1 OLD CONNA WASTE WATER PUMPING STATION

Purpose		FOR PLANNING			
Title		PROPOSED PUMP STATION & EMERGENCY 24hr STORAGE TANK SITE LAYOUT PLAN			
Original Scale	Drawn	Checked	Reviewed	Authorised	
1:200 at A1	PM	PS	PS	GH	
1:400 at A3	Date 31.09.26	Date 31.09.26	Date 31.09.26	Date 31.09.26	
Status	Drawing Number				Rev
S4	ATK-ZZ-ZZ-DR-CE-900572				P02

Irish Water Form IW-AD-EDS-FM-003			Project Design Review Contract Document and Comments Tracker		
Workshop Date:					
			WS4		
			IDD Portfolio Manager		
			ESP Feedback / Comments		
Document	Participant Name	Query ID	IW Observations / Comment	ESP Feedback / Comments	Addressed by
Planning WWPS and RM Design Report - Phase A1	Padraig Hanly	ADRL 4.1	Section 2.2 of Report - Masterplan comments sent back by UE for response. WS4 Detailed Design and WS 5 Hazop to occur later when the detailed design for the project is complete.	Noted	AtkinsRéalis
Planning WWPS and RM Design Report - Phase A1	Padraig Hanly	ADRL 4.2	Section 2.2 of report - Mentioned that character areas may change later as development plans progress. The levels of the WWPS are now being set through the review and acceptance of the masterplan and proposed WWPS inlet levels. If

Purpose	FOR PLANNING
Title	PROPOSED FOUL RISING MAINS & PUMPING STATION LONG-SECTIONS
Original Scale	1:1000 H 1: 100 V
Drawn	PM
Checked	PS
Reviewed	PS
Authorised	GH
Date	22.06.26
Date	22.06.26
Date	22.06.26
Date	22.06.26
Status	S4
Drawing Number	ATK-ZZ-ZZ-DR-CE-900581
Rev	P01

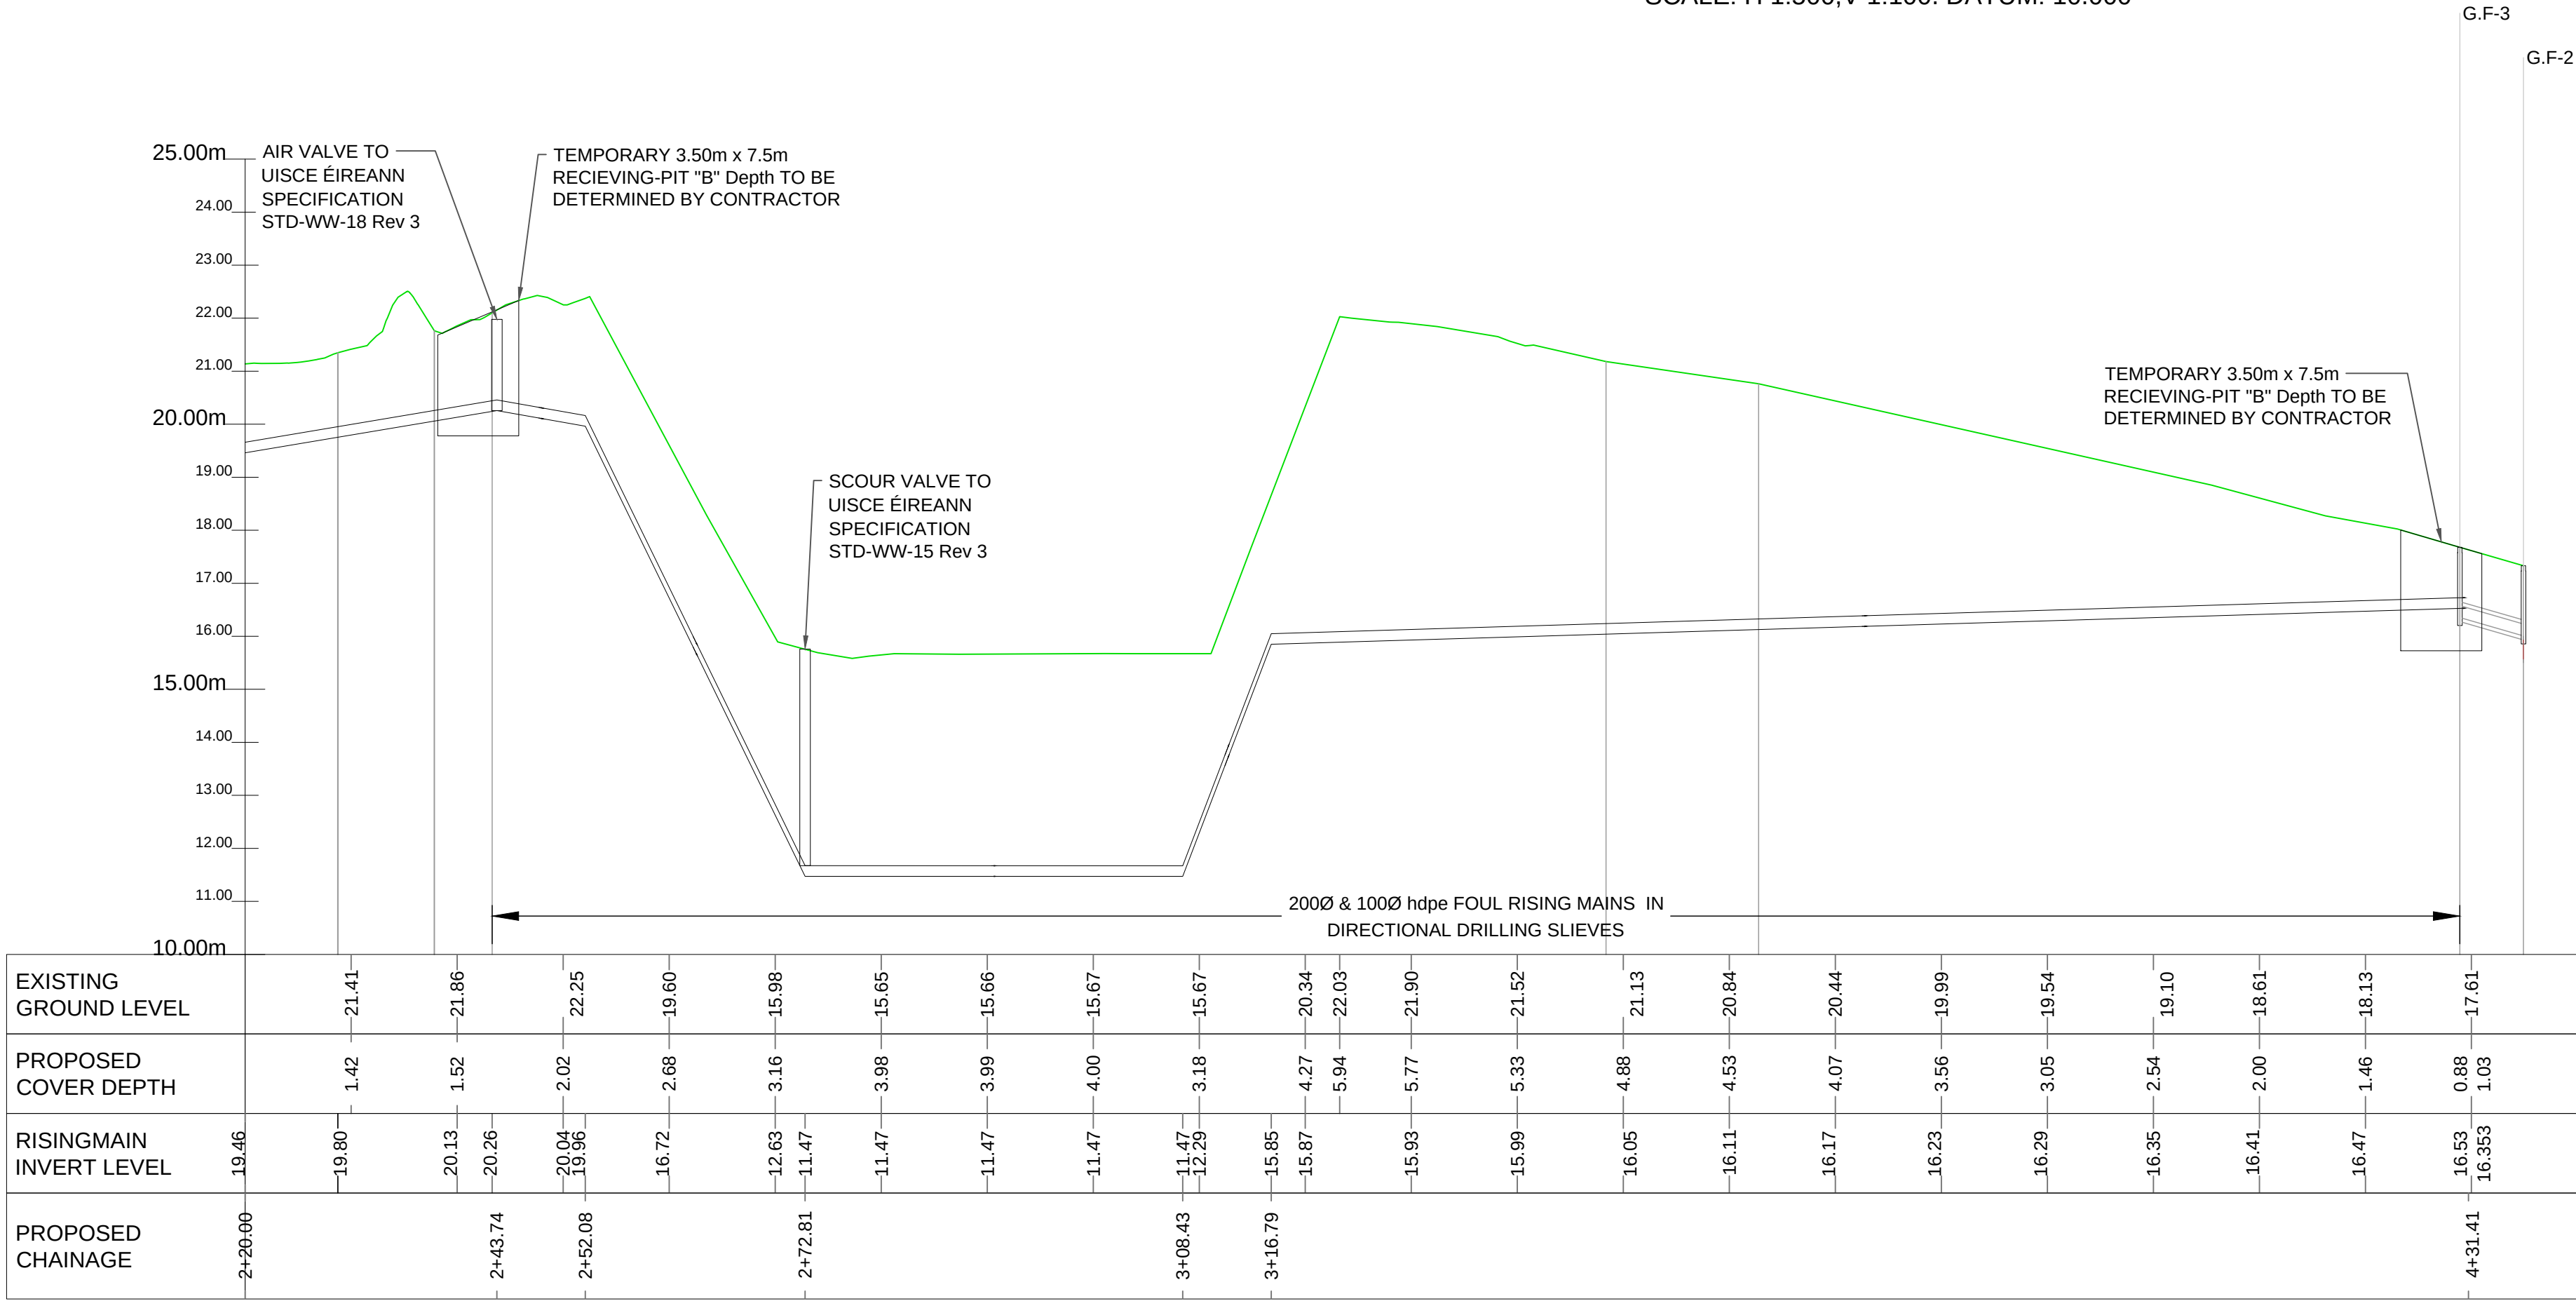
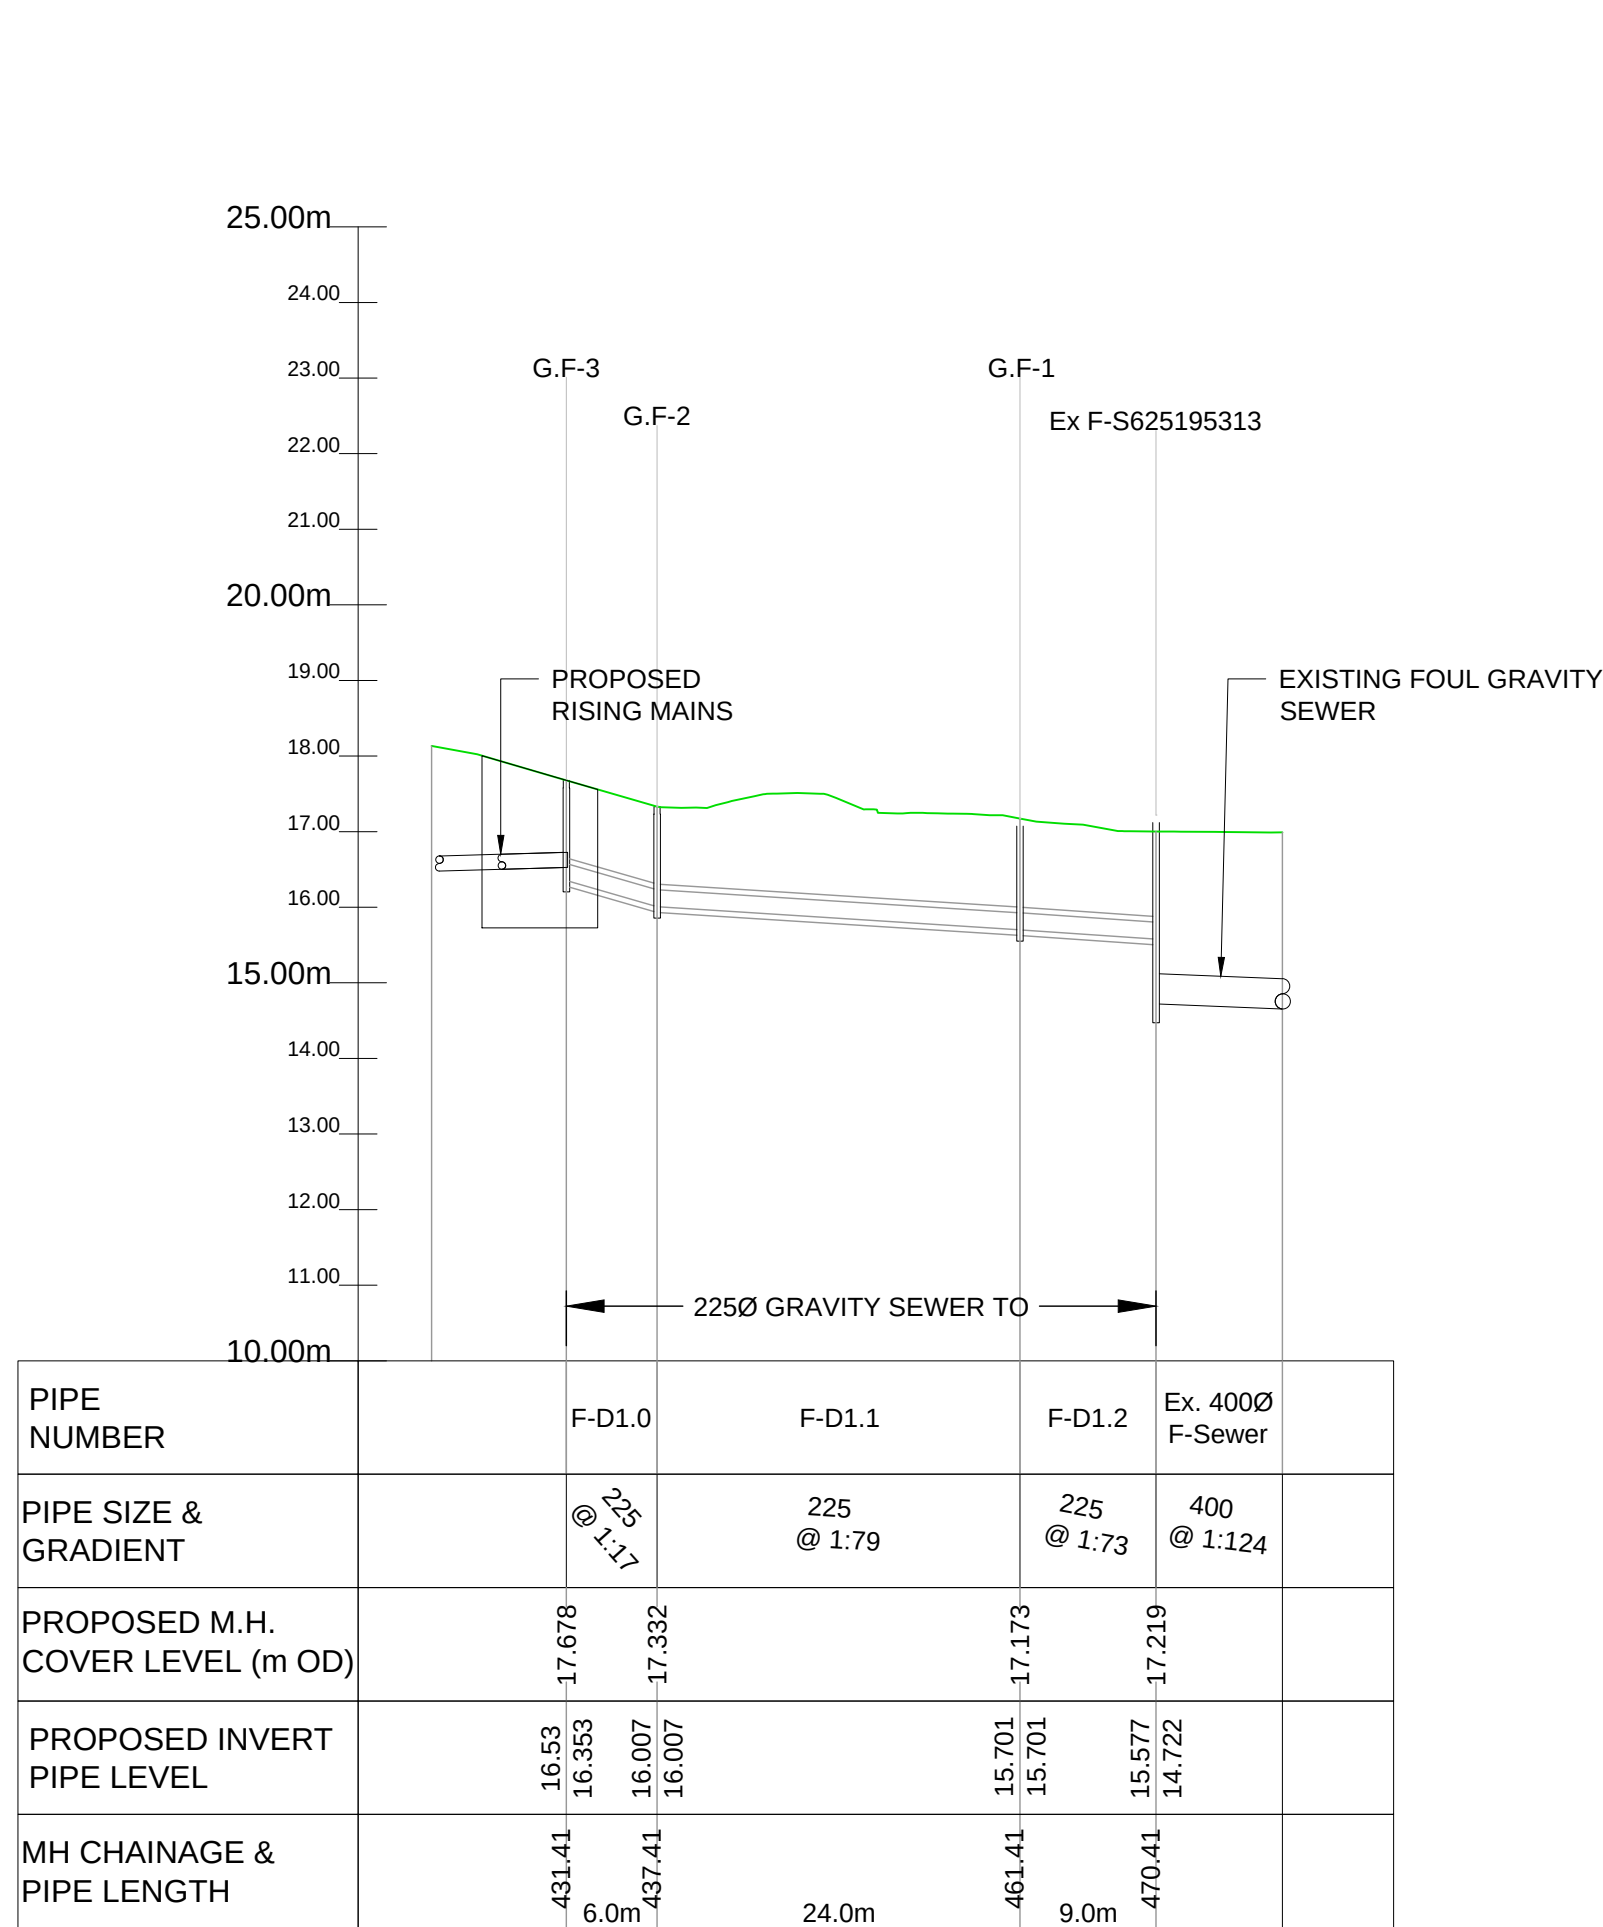
Old Conna LAP Overall Foul Drainage Strategy	Atkins (UE)	ADES 4.2	The route they propose to get to the proposed WwPs location, include the invert level they propose to gravitate to that point.	Please refer to AtkinsRéalis drawings ATK-ZZ-ZZ-DR-CE-900571 and ATK-ZZ-ZZ-DR-CE-900580 for current routes to the Pump Station. Invert Levels have been provided has part of the hydraulic mode. Drawing indicates inlet location to the proposed Pump Station. The main existing service within the LAP is the existing storm water culvert located along Old Connaught Avenue. An assessment based on know depth of the Culvert at the crossing point with the Foul drainage network from the Southern and Western Character (under the control of Glenveagh and DL RCC). Drawing ATK-ZZ-ZZ-DR-CE-900571 indicates the location of crossing the existing culvert including and clearance distance between the existing storm and proposed foul drainage. Information of crossing also provided in image below.	AtkinsRéalis
